MODEL DIVOX MK1 1994

DRAWING NUMBER 0801

P.O. 7833/JSC
100- off DINOX PCB'S

MESSAGE: *COPIES OF THE MODIFIED NETWORKS. FOR DIVOX
P.C.B. FOR YOUR APPROVAL.*

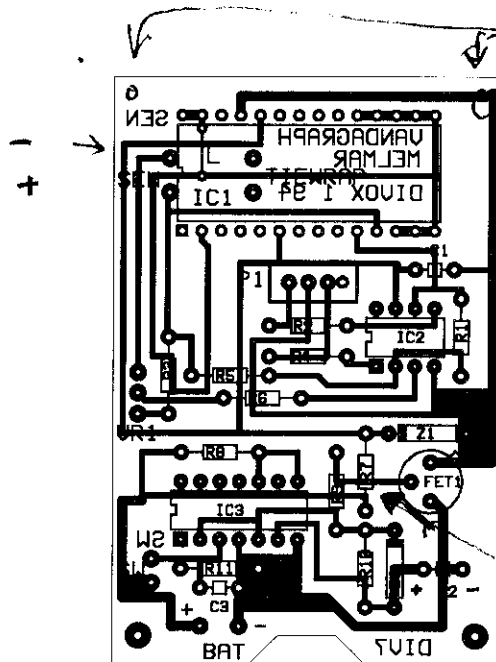
Holes to locate on case

Z1 No longer used
Component holes not required

R7 No longer used
Must Be replaced by
Taper

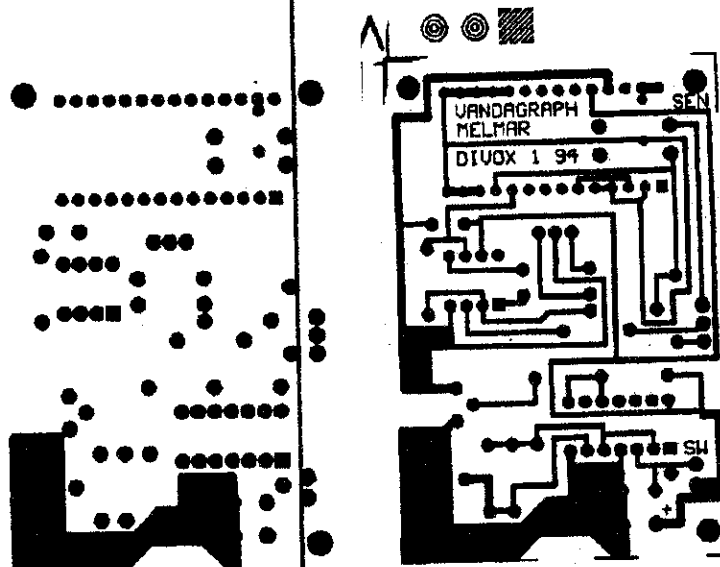
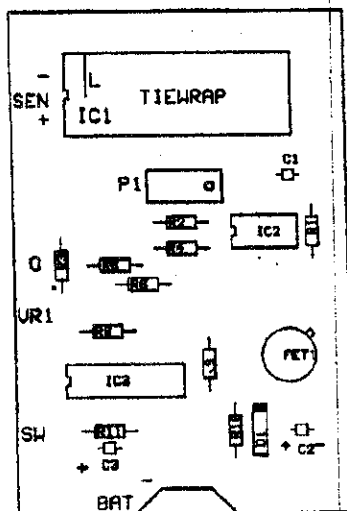
COPIES OF THE MODIFIED NETWORKS FOR DIVOX
P.C.B. FOR YOUR APPROVAL. HOPE ALL'S O.K.
BEST REGARDS.

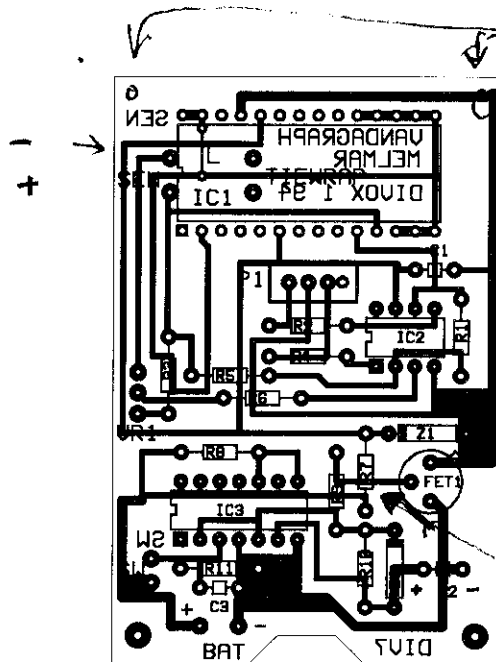
Holes to locate on case

Z1 No longer used
Component holes not required

R7 No longer used
Must Be replaced by
Taper
